N3383A-01B**S E R V I C E****N O T E**Supersedes:
N3383A-01A**N3383A PNA Series RF Network Analyzers**

Serial Numbers: 00000000 thru 46999999

July 26, 2007

Figure 1

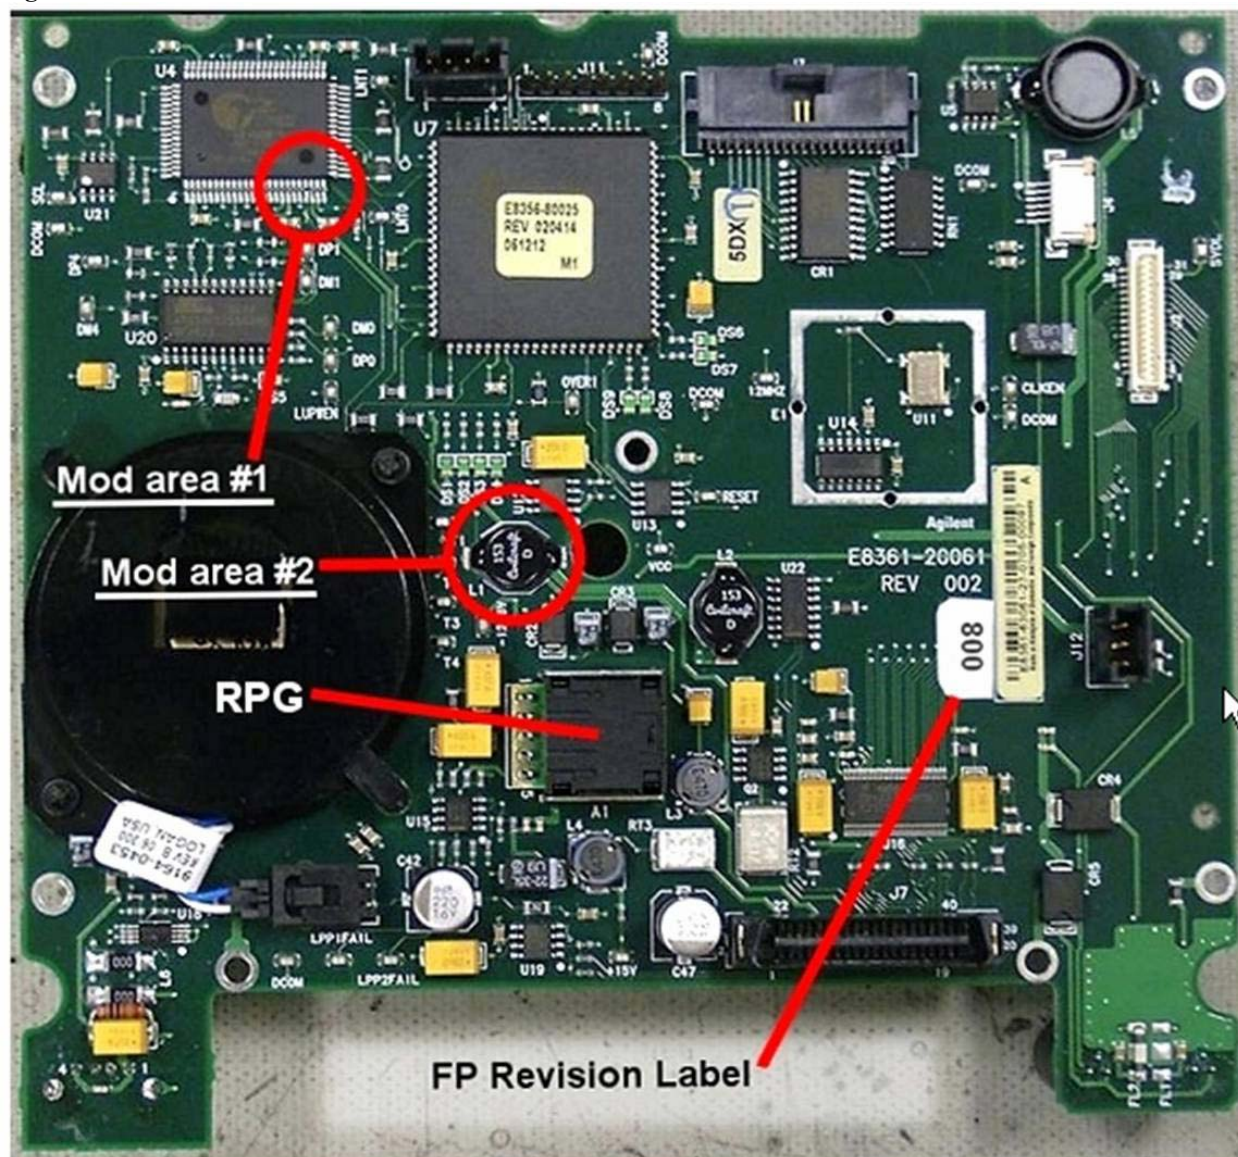
FPI boards E8356-60209 and the older E8356-60029 were both identified as causing a serious “won’t boot” condition and a USB signal integrity issue. These issues were noticed in production as well as service centers. The booting issue was due to a tantalum capacitor (C58, 4.7uF, and 50V) reversed biased at 10 percent of its rated voltage. Both issues were fixed with a board layout change of the E8361-63061, revisions 001 to 007 FPI boards. Older E8361-63061 revision 008 FPI boards were identified as having an intermittent front panel keyboard and RPG lockup problems. This problem has been traced to an incorrect voltage applied to a pin on the U4 IC.

The Agilent Service Parts Organization is currently stocking E8361-63061 revision 009 FPI boards. This board should be used to replace the E8356-60003, E8356-60029, E8356-60209, E8361-63061 revisions 001 to 007, and E8361-63061 revision 008 FPI boards. Rather than replacing the E8361-63061 revision 008, it can be modified using the information on pages 3 and 4.

Refer to Figure 1 for the two modification areas to be addressed. Note that while this picture happens to show the FPI board completely removed from the front frame assembly, this is not necessary to perform the required modifications.

- Modification #1 consists of shorting two pins of U4 together with a small amount of solder.
- Modification #2 consist of removing L1.

Unsolder and completely remove the black surface mount inductor L1 from the front panel assembly board. This is no longer needed and can be discarded.

Figure 2

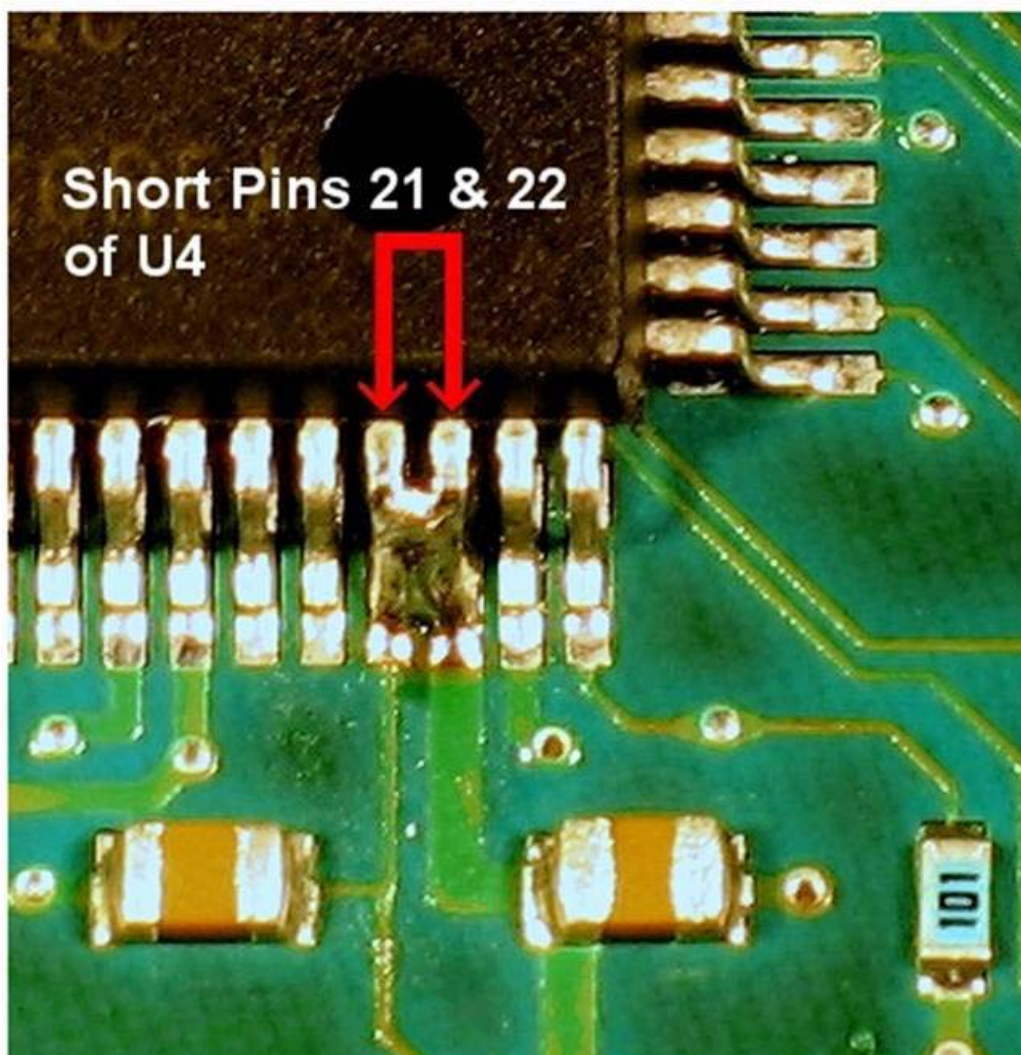
Modification #1

Carefully solder pins 21 and 22 together on U4. Refer to Figure 2 for the exact location. Use care so that no other pins are shorted. Use of a very fine tip soldering iron is recommended and a large work-task magnifying glass is very helpful.
